Model: General		Date: 23-Jan-06	No.: RGene021
Subject: Data Overwrite Security Unit Installation		Prepared by: H.Matsui	
From: 2nd Tech Support Sec. Service Support Dept.			
Classification:	<input type="checkbox"/> Troubleshooting	<input type="checkbox"/> Part information	<input type="checkbox"/> Action required
	<input type="checkbox"/> Mechanical	<input type="checkbox"/> Electrical	<input checked="" type="checkbox"/> Service manual revision
	<input type="checkbox"/> Paper path	<input type="checkbox"/> Transmit/receive	<input type="checkbox"/> Retrofit information
	<input type="checkbox"/> Product Safety	<input type="checkbox"/> Other ()

Service Manual Revision

Replace the installation procedure for the Data Overwrite Security Unit Type C or D with the procedure in this RTB (from pg. 2).

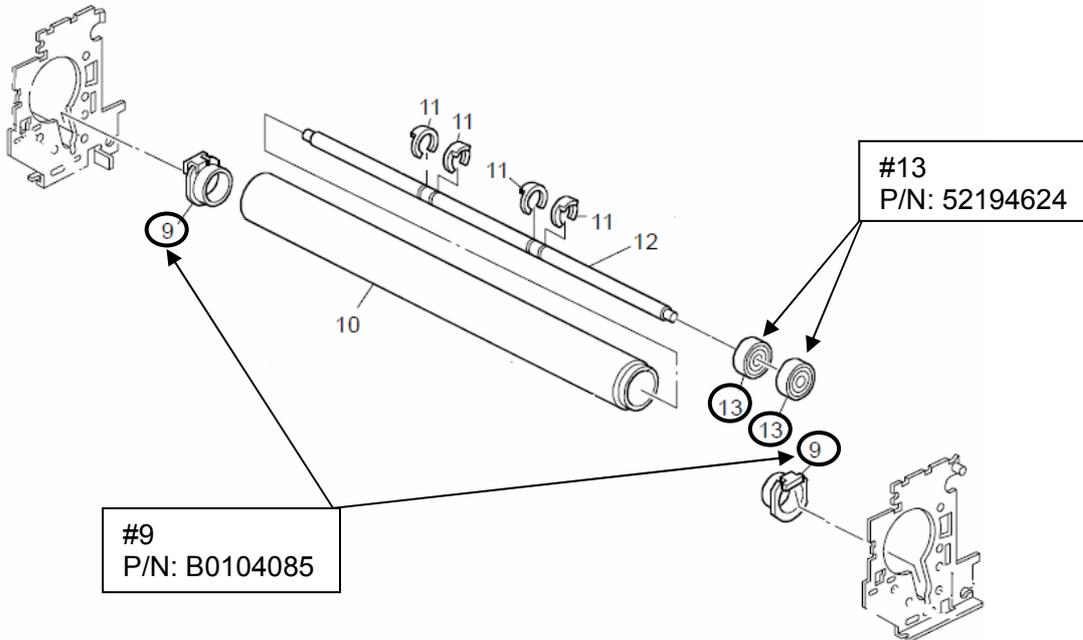
Part number	Description	Q'ty	Page	Index	Note
Incorrect	52194624	Ball Bearing – 20x42x12	2	57	9	
	B0104085	Pressure Roller Holder	2	57	13	
Correct	52194624	Ball Bearing – 20x42x12	2	57	13	
	B0104085	Pressure Roller Holder	2	57	9

Change/Reason: The index numbers in the parts list were corrected as shown.

30. Electrical Section 1 (B188)

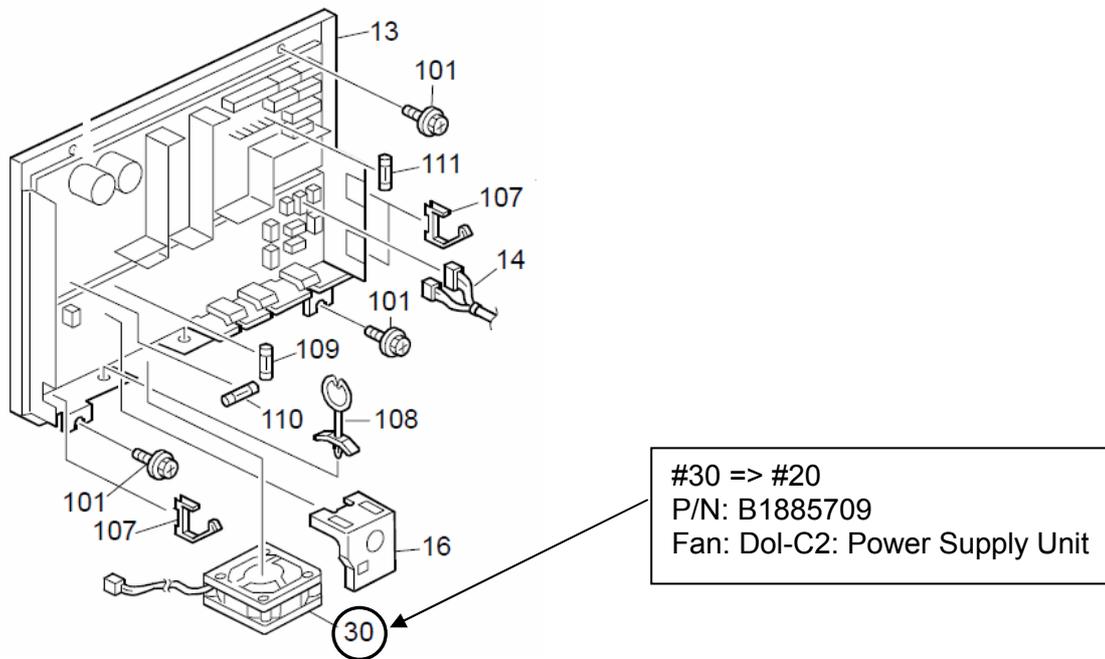
Change/Reason: The index number in the illustration was corrected as shown.
